**ADDENDUM NO. 1  
TO CONTRACT DOCUMENTS FOR THE  
PERMANENTE CREEK FLOOD PROTECTION PROJECT-  
CHANNEL IMPROVEMENTS  
Project No. 26244001; Contract No. C0625**

**ADDENDUM NO. 1  
PERMANENTE CREEK FLOOD PROTECTION PROJECT  
CHANNEL IMPROVEMENTS**

**REPLACE** in their entirety the following drawings (**ATTACHMENT 5**):

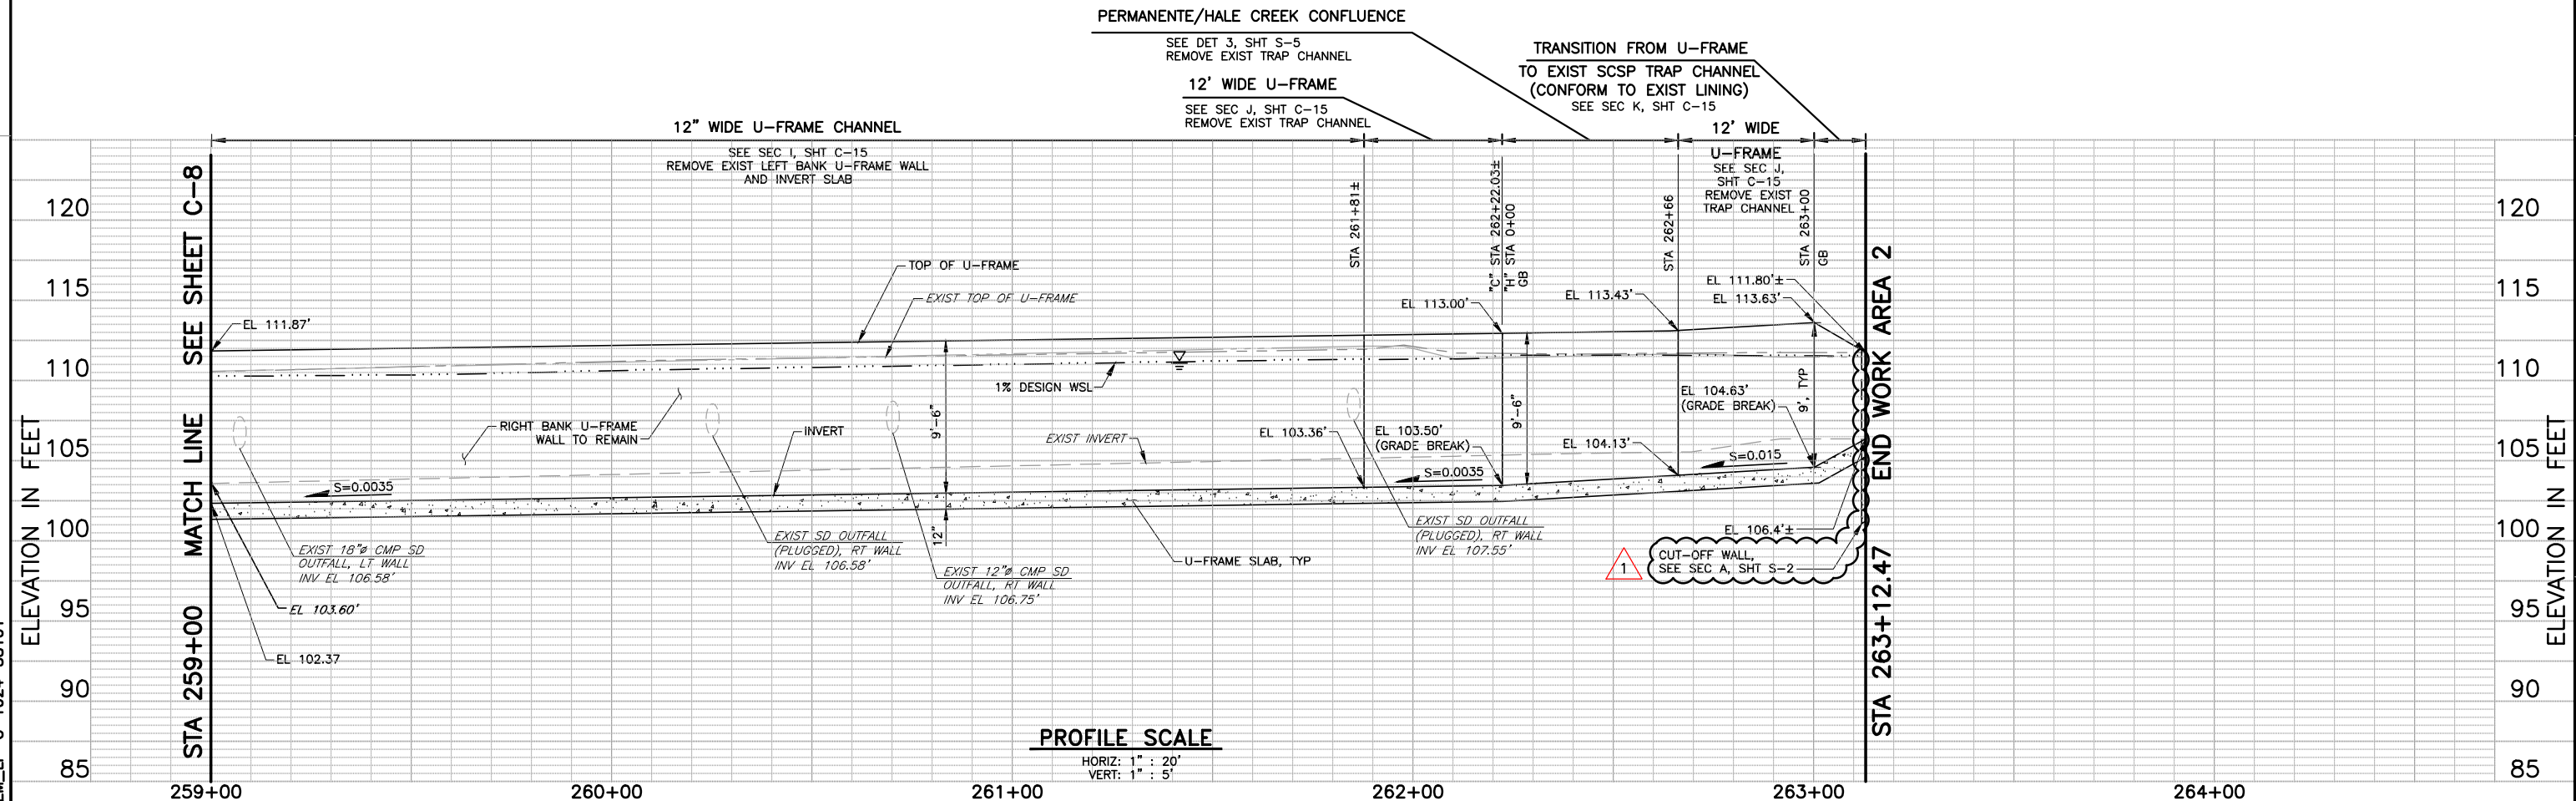
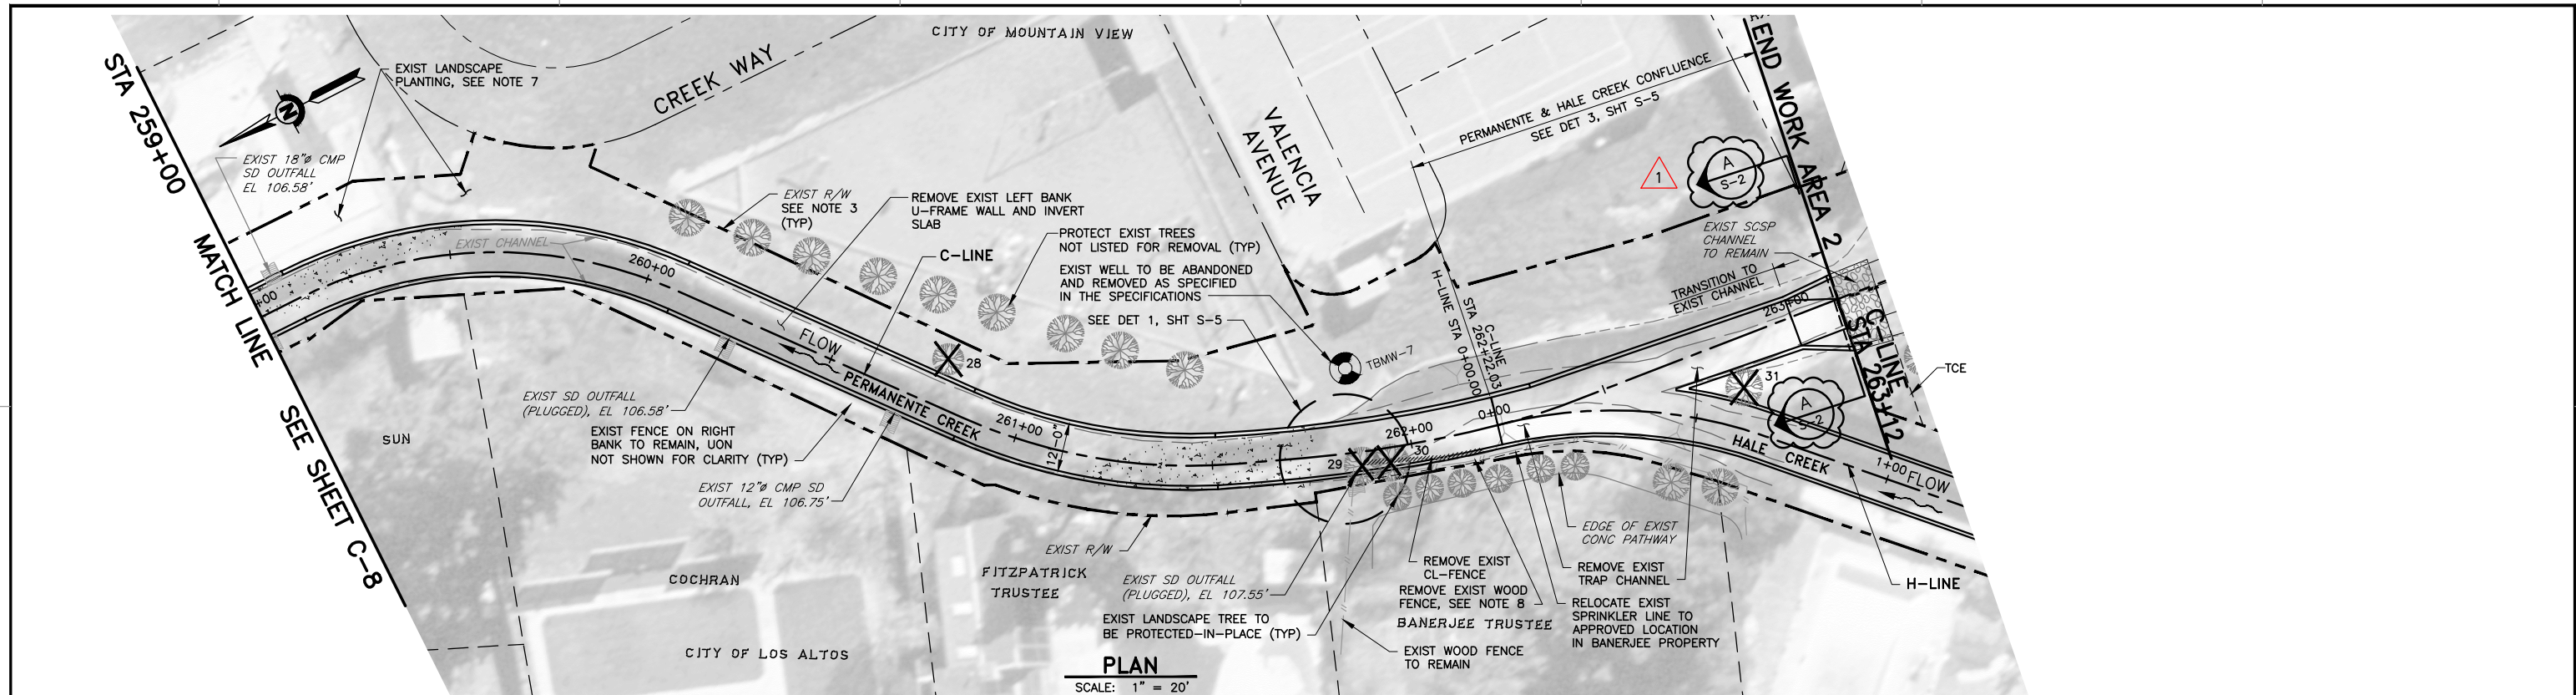
Response 28	It is W6x16. Please refer to this Addendum No.2, Sheets S-6 and S-7.
Question 29	On Sheet C-9 at approx. Station 250.00 to 250+50, it shows the existing Right of Way on the right side of the channel to be 11' off the existing channel. However, in the field, the property owners fence is up against the channel. Is the Contractor to assume that we will be able to have the 11' buffer or is the District going to attain the existing Right of Way's indicated on the plans? Please clarify.

Question 2	The engineer’s estimate shows there are three Monitoring Wells that need to be abandoned and removed however, there appears to only be two on the plans (Sheets C-1 & C-9). Please confirm there are only two wells that need to be abandoned and removed or provide information on the third well. Also, there are no details regarding the diameter and depth of the existing wells that require removal in/on the specifications and drawings. Please confirm if the well casings are steel or PVC casings, the depth of the wells, if these are Above Ground monuments or Flush Grade well covers, and if there are any bollards that are needed to be removed in the process.

Response 29	No, the Contractor is not to assume that they will have the buffer.
Question 30	On sheet C-3, in the profile view, Station 118+7 you have Top of Wall at EL 20.33' and bottom of footing at EL 15.33'. So that's 5' from top of wall to bottom of footing, but the dimension shown in both the profile view and the detail on Sheet S-2 show 5'-10" from Top of Wall to Bottom of Footing. Can you confirm which is correct?

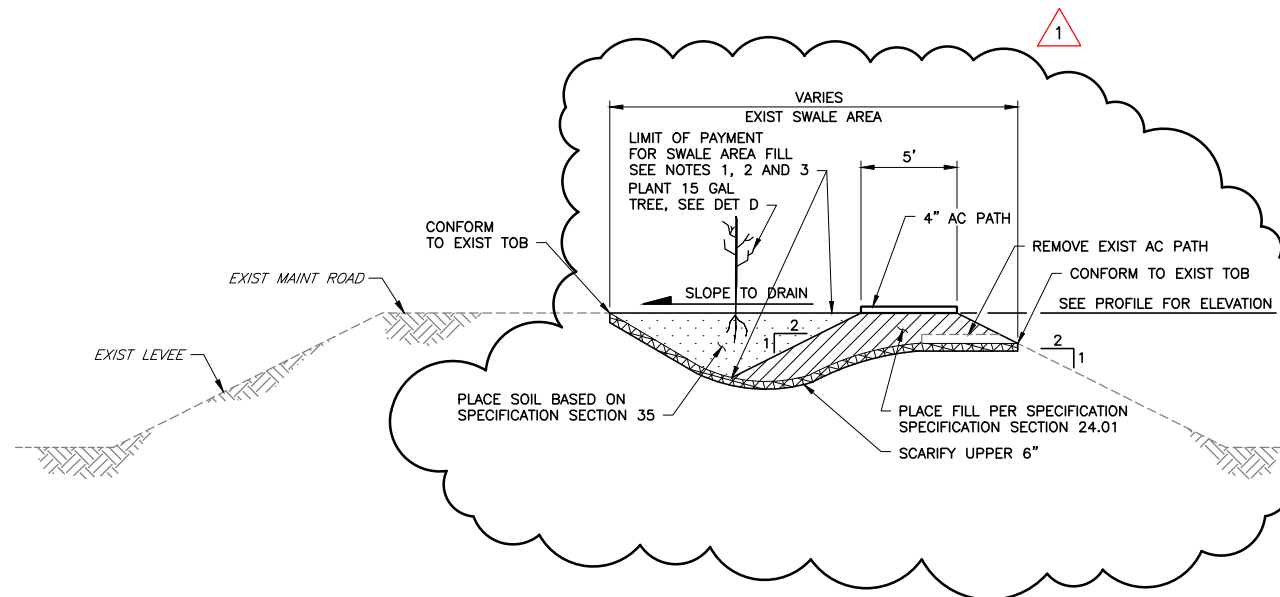
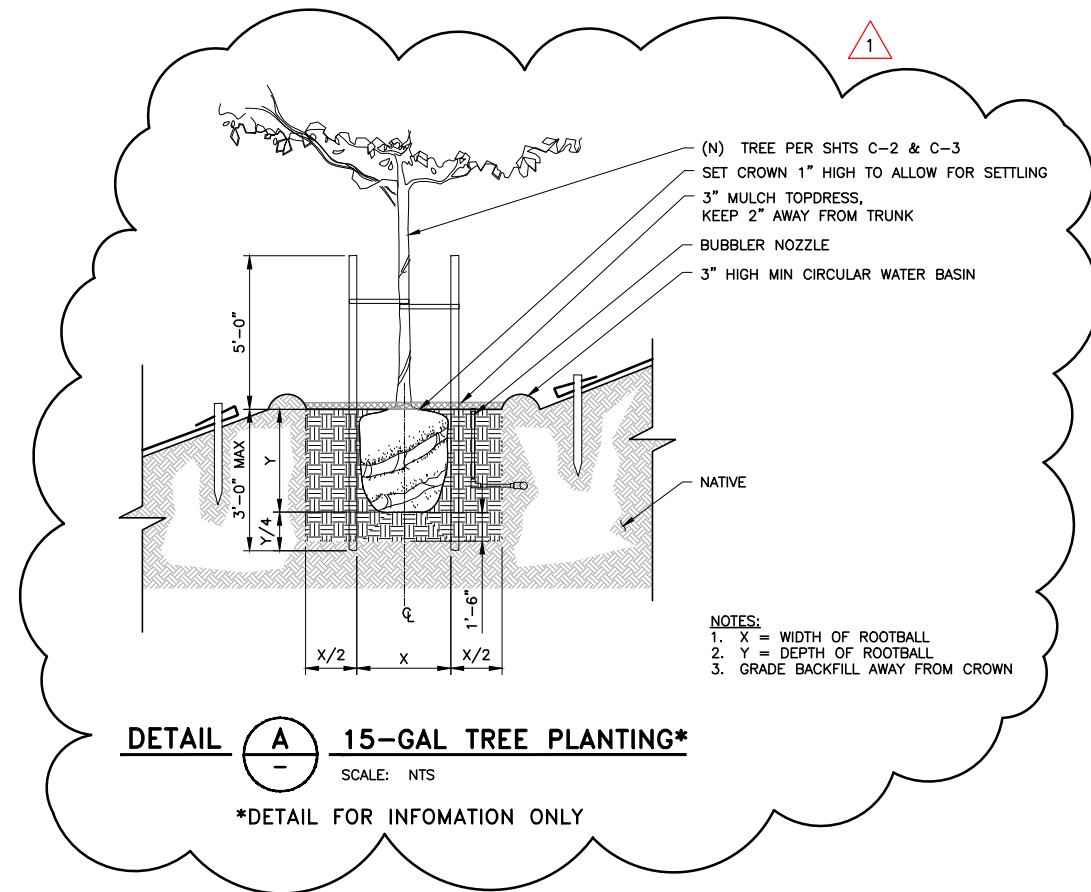
Question 21	What type of hydroseed mix is specified for use per note "hydroseed exposed soil" on Sheet C-17 Section A? And does this include all exposed soil for Levee Raising, Swale Area Fill, and Flood Wall Construction Sheets C-1 through C-6? Please clarify.

Response 21	For the Levee Raising, see this Addendum No. 2, Article 24.13  For the Swale Area Fill, see this Addendum No. 2, Article 35.  For the Flood Wall Construction between Charleston road and Highway 101, no hydroseeding will be necessary.

SCALE AS SHOWN	PROJECT NUMBER <b>26244001</b>
VERIFY SCALES  BAR IS ONE INCH ON ORIGINAL DRAWING <b>DATE: 11/2/2012</b>	SHEET CODE: <span style="border: 1px solid red; padding: 2px;">1</span> <b>S-6</b> SHEET NUMBER: 42 OF 66

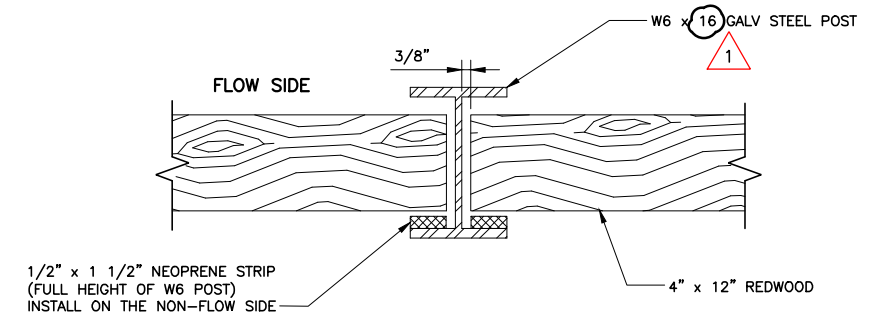
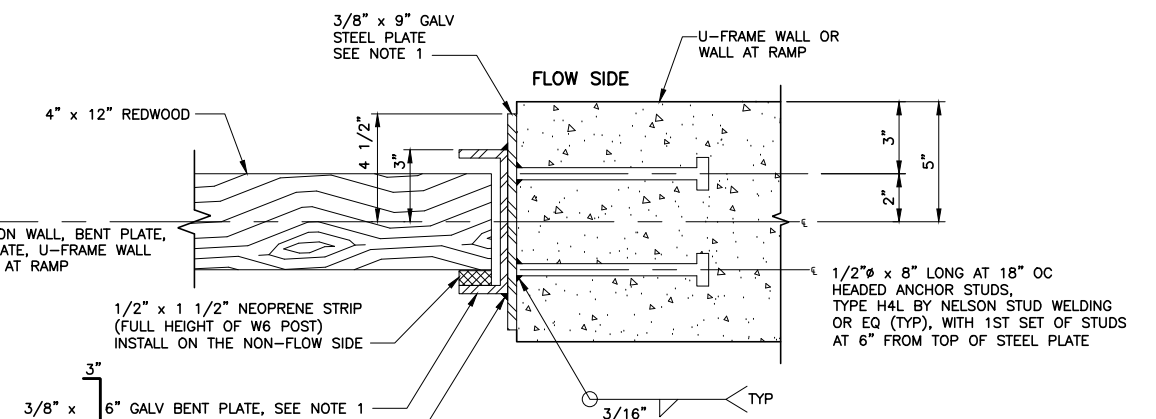
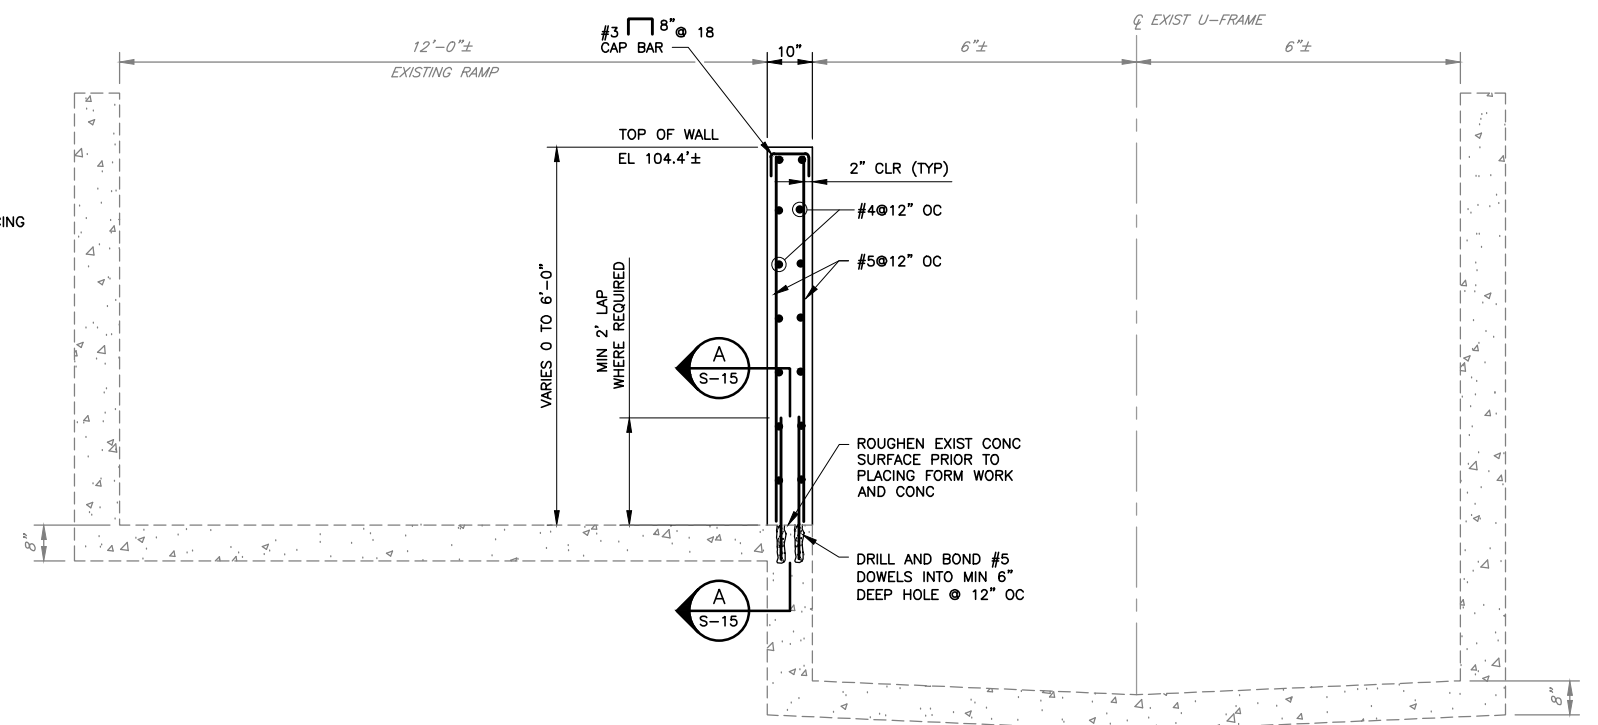
Response 23	Please refer to this Addendum No.2, Sheet S-2.
Question 24	Separation Wall detail 3/S-6 shows the 4" x 12" Redwood without spacing. Is the intent to put one piece of redwood only? If one piece only, how is it supported?

Response 27	Please refer to this Addendum No.2, Sheet S-9.
Question 28	The galvanized steel post for the separation wall shown in detail 3/S-6 is WF6x15 while on detail A/S-7, it is W6x16. Please clarify.

Response 24	Detail 3, SHT S-6 is a blowup detail of the plan view shown on Detail 1, SHT S-6. Please refer to Detail 1, SHT S-6 for post spacing.

SCALE AS SHOWN	PROJECT NUMBER <b>26244001</b>
VERIFY SCALES  BAR IS ONE INCH ON ORIGINAL DRAWING IF THIS IS NOT AN ADJUST SCALES ACCORDINGLY	SHEET CODE: <span style="border: 1px solid red; padding: 2px;">1</span> <b>S-7</b> SHEET NUMBER: 43 OF 66

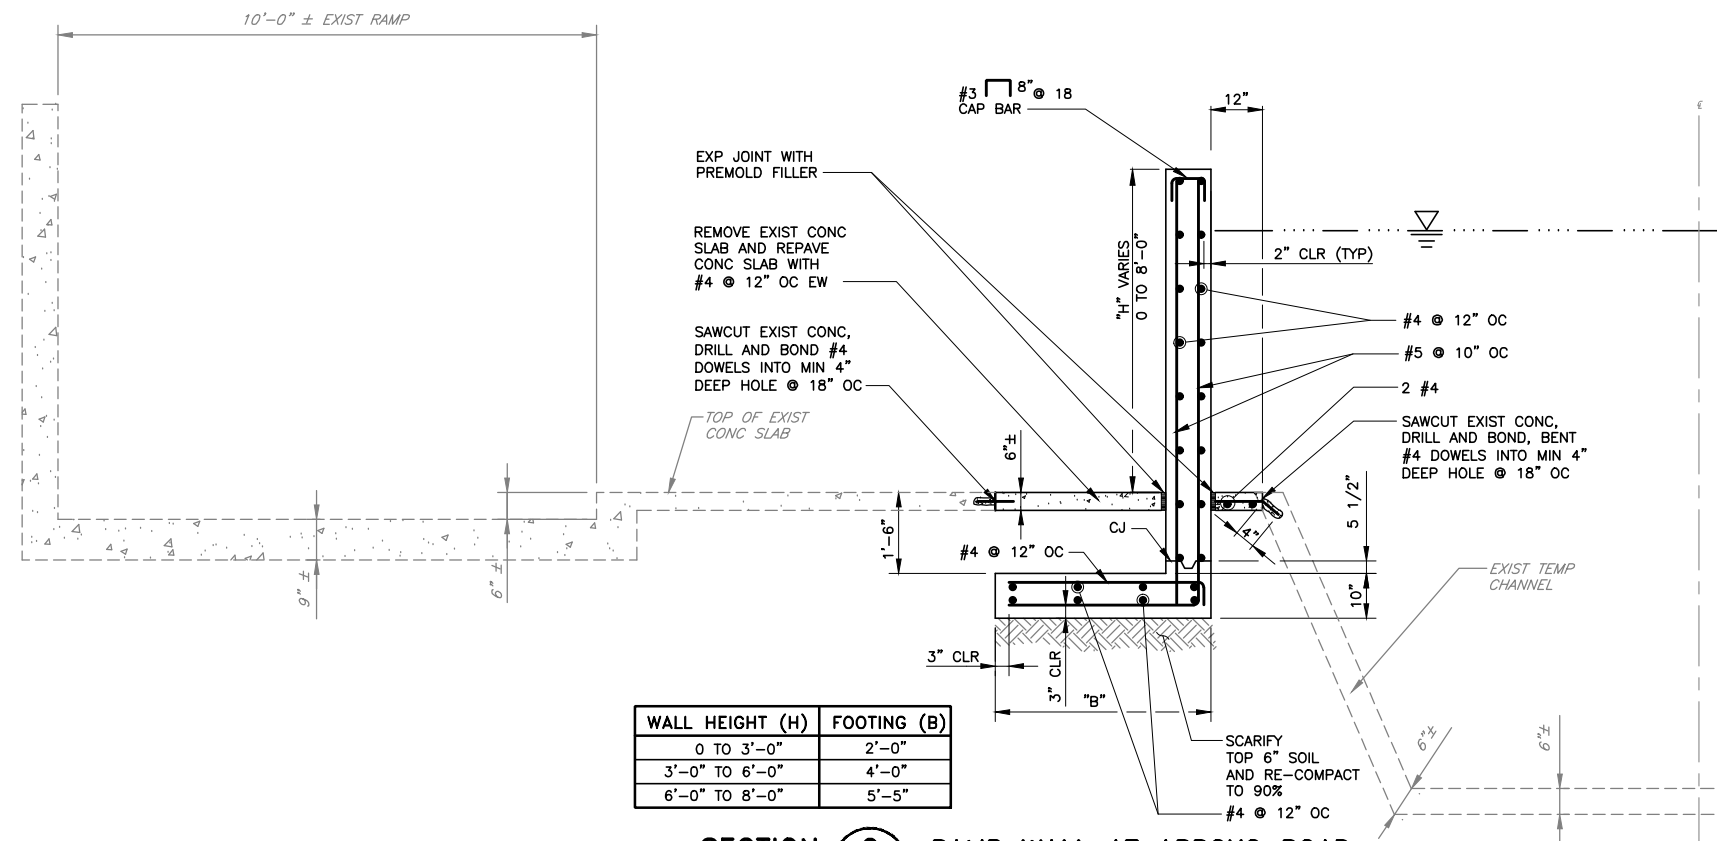
Question 35	Is the call out on Section A Removable Steel Post on sheet S-7 " 18" x 20" x 3'-0" deep Footing GALV" correct? Or should the word GALV be deleted?

Response 35	Please refer to this Addendum No. 2, Section A, SHT S-7.
